■ INTERIOR

1. Instrument Panel

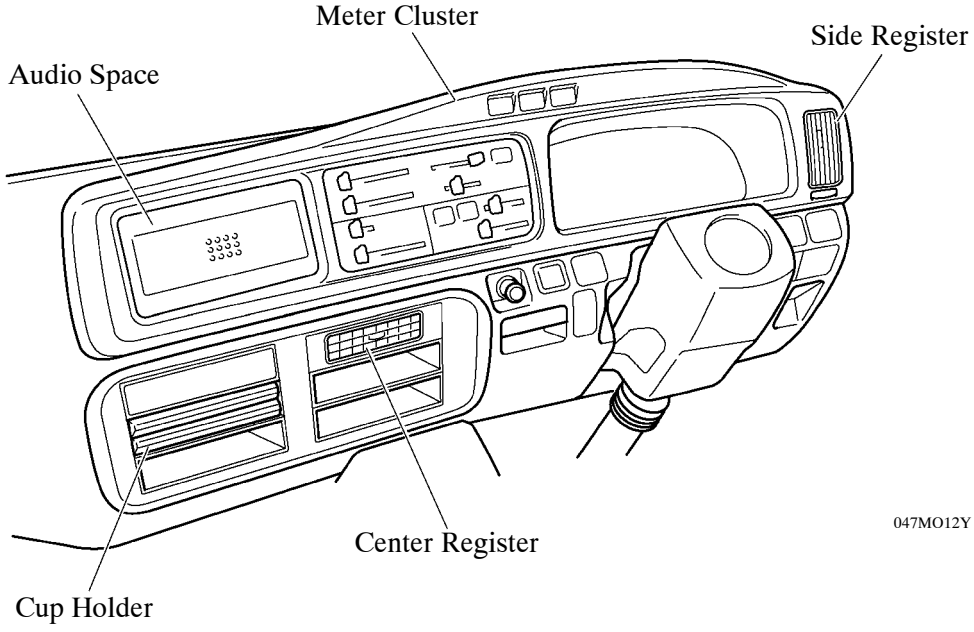
The design of the instrument panel has been changed on the RHD models, excluding the Europe models. The changed items are as follows:

- The design of the meter cluster and meter hood has been changed.
- Along with the changes in the meter cluster, the shape of the register on the driver's side has been changed.
- As an audio space is located in the meter cluster, the position of the center register has been changed. In addition, the positions of the switches and the cup holder in the center of the instrument panel have been changed.
